EPA Comments

SUBJECT: Comments on "DRAFT REPORT - Dam Safety Assessment of CCW Impoundments: TVA Gallatin Power Plant"

Re: Response to Recommendations
USEPA CCR Impoundment Assessment DRAFT Report
Gallatin Fossil Plant (GAF)
Gallatin, Tennessee

TENNESSEE VALLEY AUTHORITY (TVA) – COMMENTS ON COAL ASH SITE ASSESSMENT ROUND 11 DRAFT REPORTS FOR ALLEN (ALF), BULL RUN, (BRF) COLBERT (COF), CUMBERLAND (CUF), GALLATIN (GAF), JOHN SEVIER (JSF), JOHNSONVILLE, (JOF) KINGSTON (KIF), PARADISE (PAF), SHAWNEE (SHF), WATTS BAR (WBF), AND WIDOWS CREEK (WOF) FOSSIL PLANTS

**Section M - Stilling Pond C
 Gallatin Fossil Plant
 Gallatin, Tennessee**

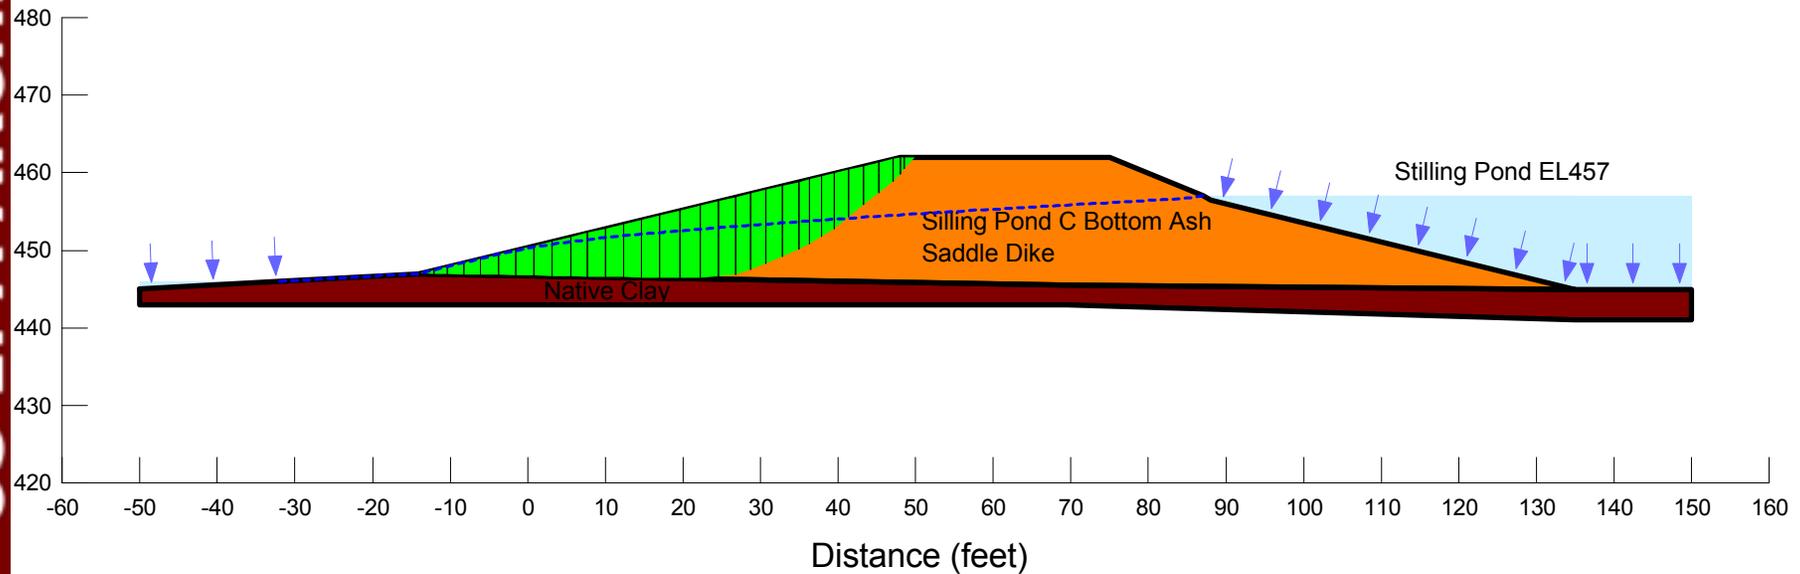
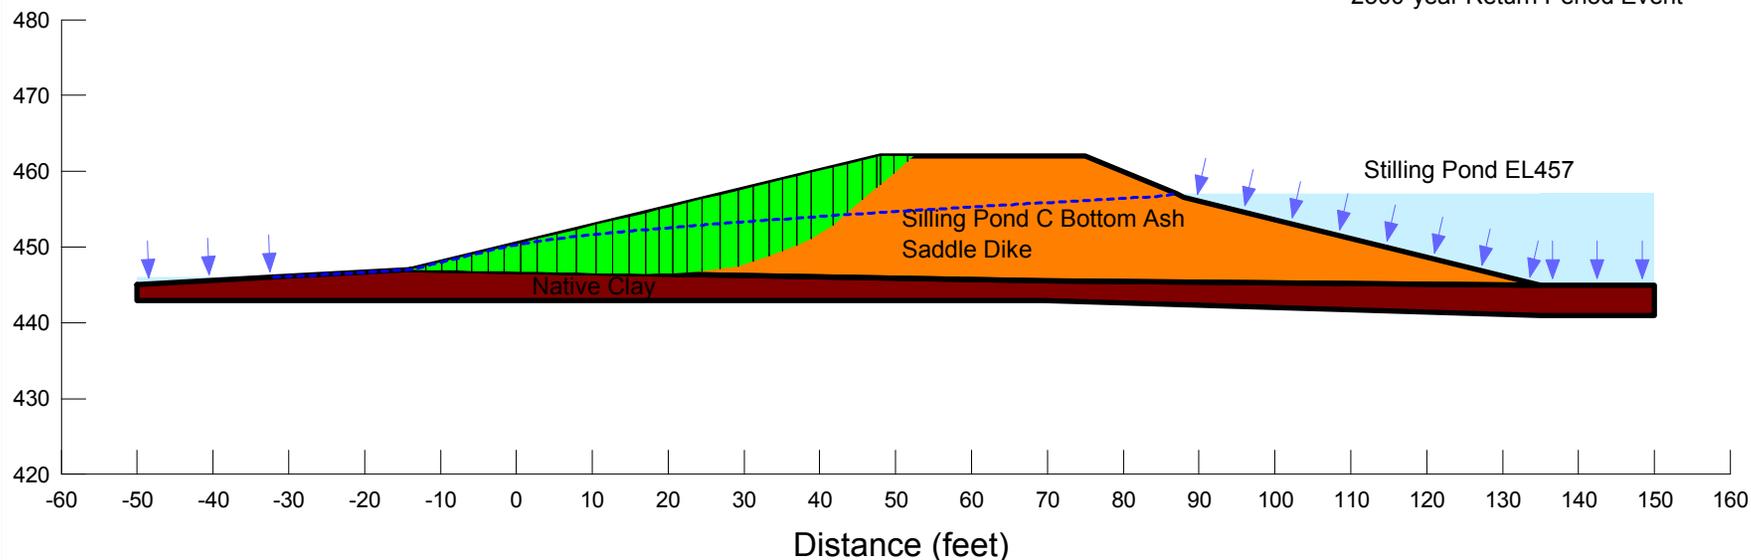
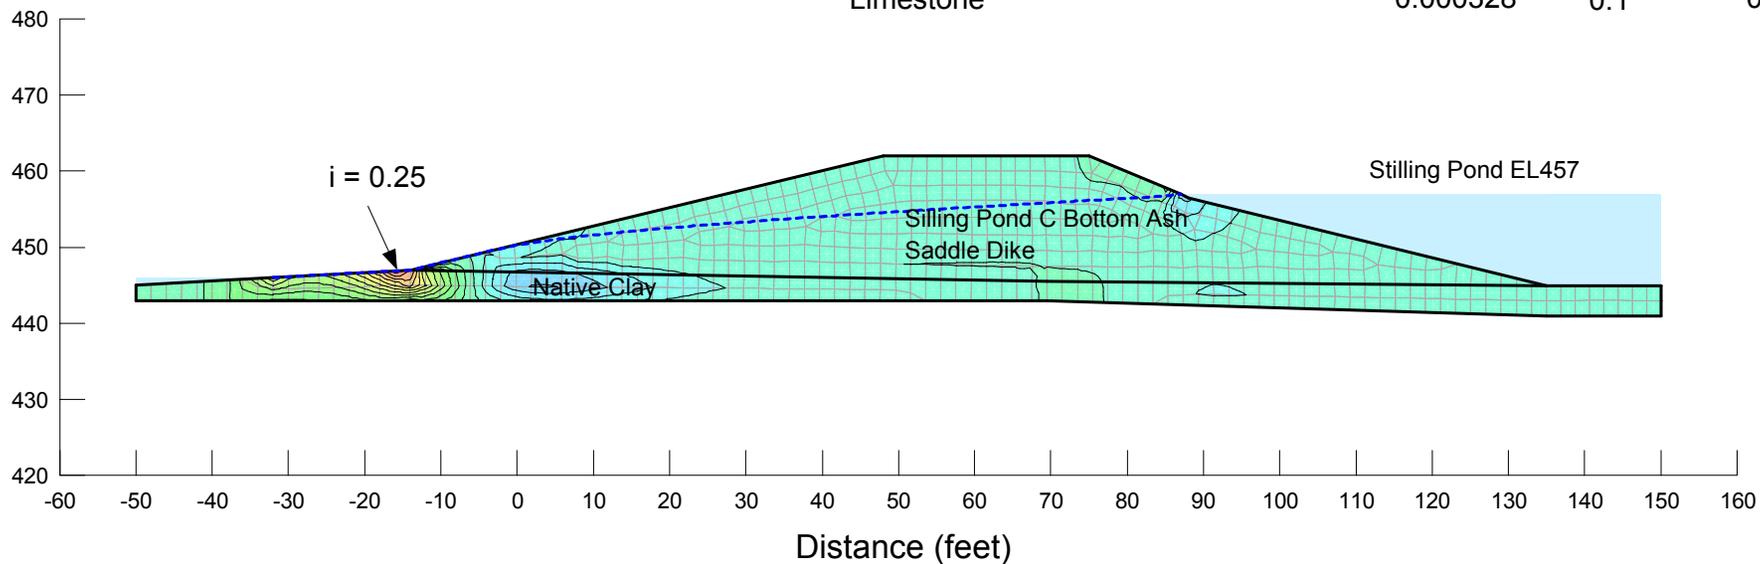
Dewberry Report Section 1.2.3 2) – Stilling Ponds: Perform slope stability analyses for all credible static and seismic loading conditions, as well as piping potential analyses, for the stilling pond complex saddle dikes (Ponds C and D) to verify and document that these dikes have adequate structural stability.

Response: Stantec has performed the additional analysis recommended by Dewberry including 1) seepage analysis, and 2) pseudostatic (seismic) and long-term (static) slope stability analysis for Sections M (Pond C saddle dike) and N (Pond D saddle dike). The results indicate that the target factors of safety are satisfactory. The results are attached.

Long Term Factor of Safety: 1.8

Factor of Safety: 1.2
 Horizontal Seismic Coefficient $K_h = 0.108g$
 2500-year Return Period Event

Piping Potential
 Maximum occurs at (-16, 446.89)
 Total Head = 446.89 ft
 At (-16.03, 444.93)
 Total Head = 447.38 ft
 dH = 0.49 ft dL = 1.96
 i = 0.25 i(critical) = 1.00
 FSpiping = 4.0

**Section K - Bottom Ash Pond A
Gallatin Fossil Plant
Gallatin, Tennessee**

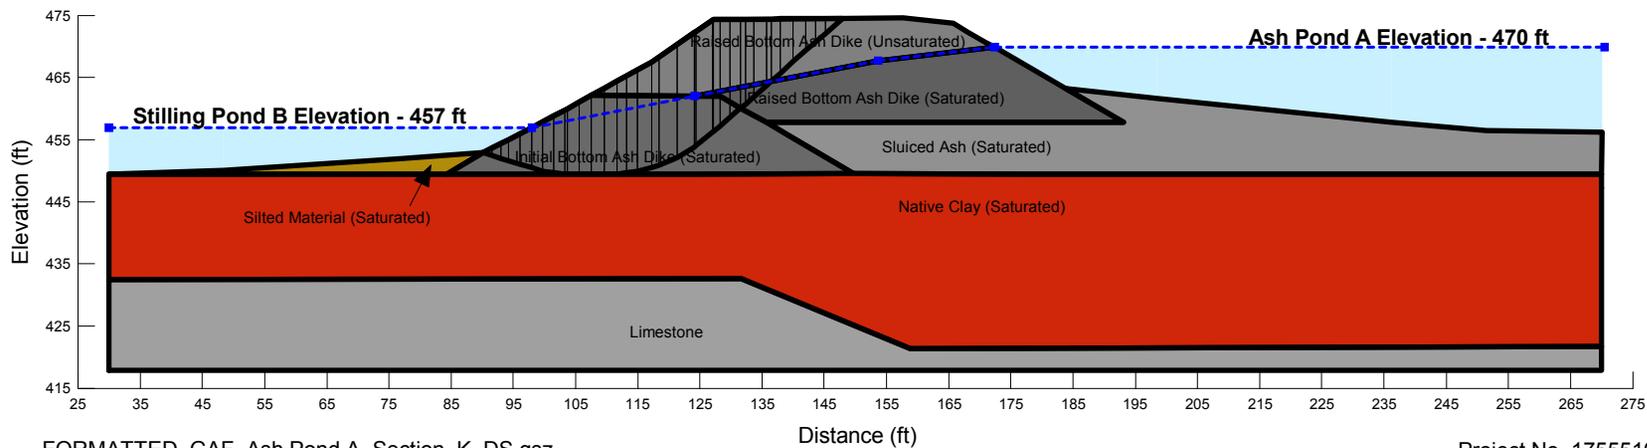
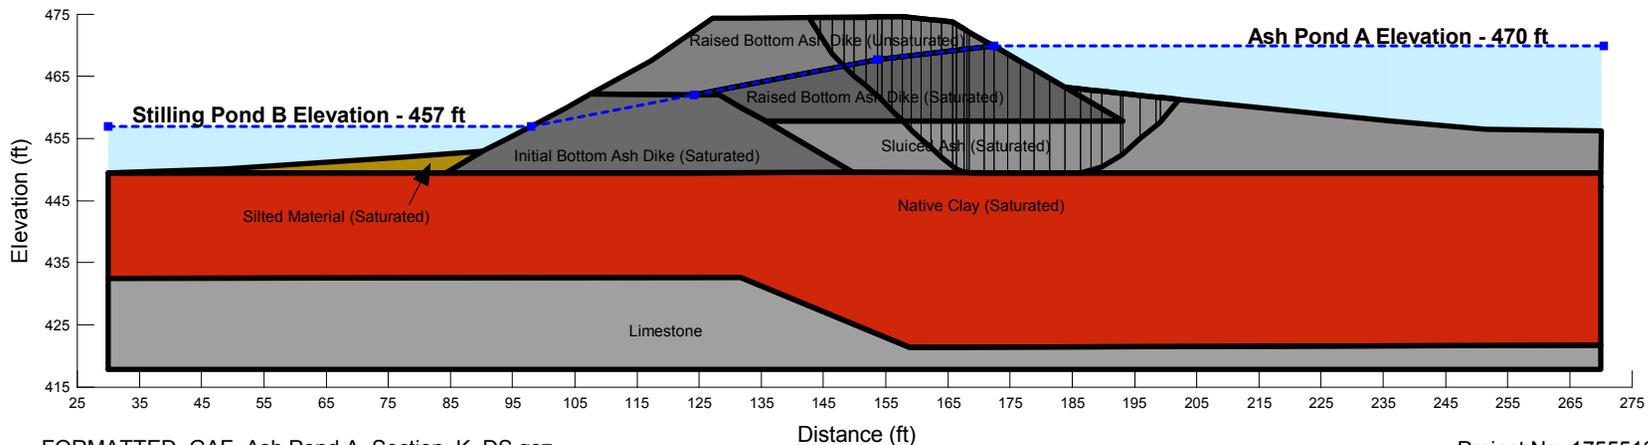
Dewberry Report Section 1.2.3 1) – Ponds A and E: Perform a quantitative liquefaction analysis of dike raise embankment sections overlying sluiced ash at the Bottom Ash Pond A and Fly Ash Pond E; evaluate the impact of liquefaction on the sluiced-ash supported sections of the containment dikes, if liquefaction is indicated; and evaluate the consequences of liquefaction failure of these sections of the containment dikes.

Response: Stantec performed a liquefaction potential assessment based on ground motion estimates for the 2,500-year earthquake scenarios, Standard Penetration Test borings, and corresponding laboratory test results. A description of the methodology and the results (ground response analysis and factor of safety against liquefaction versus elevation plots) are attached. Consistent with previously submitted seismic stability analyses, Section K was analyzed for Pond A and Section B was analyzed for Pond E. The saturated bottom ash dike materials and the saturated sluiced ash materials are anticipated to undergo liquefaction for the 2,500-year earthquake.

Based on the results of the liquefaction potential assessment, residual strengths were assigned to the liquefied materials and post-earthquake static stability analysis was performed. A description of the methodology and the results (slope stability cross sections, including table of material parameters) are attached. The results indicate that Pond A Section K and Pond E Section B both have factors of safety greater than or equal to the target threshold value of 1.0; thus, the dikes will remain stable and will not undergo significant liquefaction-induced deformations due to the 2,500-year earthquake.

Factor of Safety: 1.0

Factor of Safety: 1.2
